DOCKETED

GREAT OAKS SOUTH BACKUP GENERATING FACILITY SMALL POWER PLANT EXEMPTION

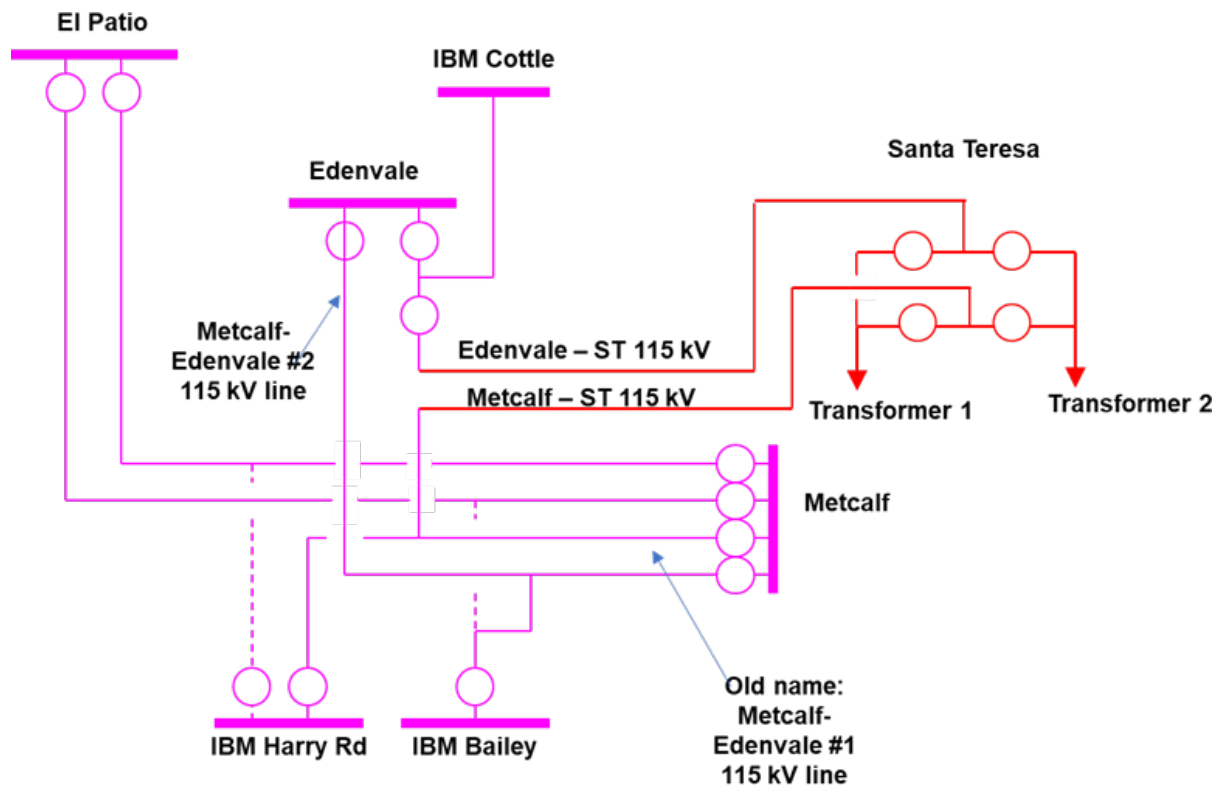
1. PG&E will submit a clarification on how and when the second and third transformers be installed to serve the anticipated GOS load.
